565 WESLEY ACRES ROAD | COMMENTS & RESPONSE MATRIX
 (PRINCE EDWARD COUNTY) FILE NO. SP-06-25
 CAMPFIRE CIRCLE

Last Updated: 14-JAN-2026

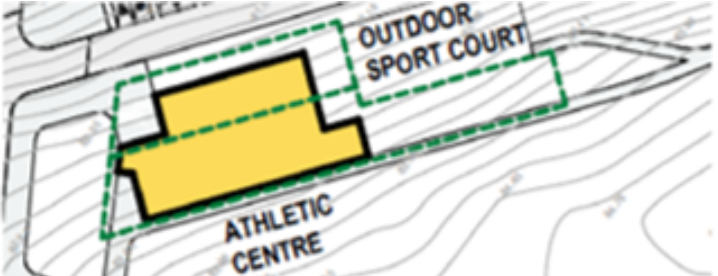
1.7	General Site Plan Notes				
1.7.1	Please clarify the green dashed line around buildings. Is this intended to be the foundation footprint or to denote something else? Please clarify this line, see example below: 	THA/TEEPLE			Complete

1.7.2	Please ensure all linework is identified in the Legend.		Dashed line reflect the roof profile so we can demonstrated coverage	Proposed Overall Site Plan
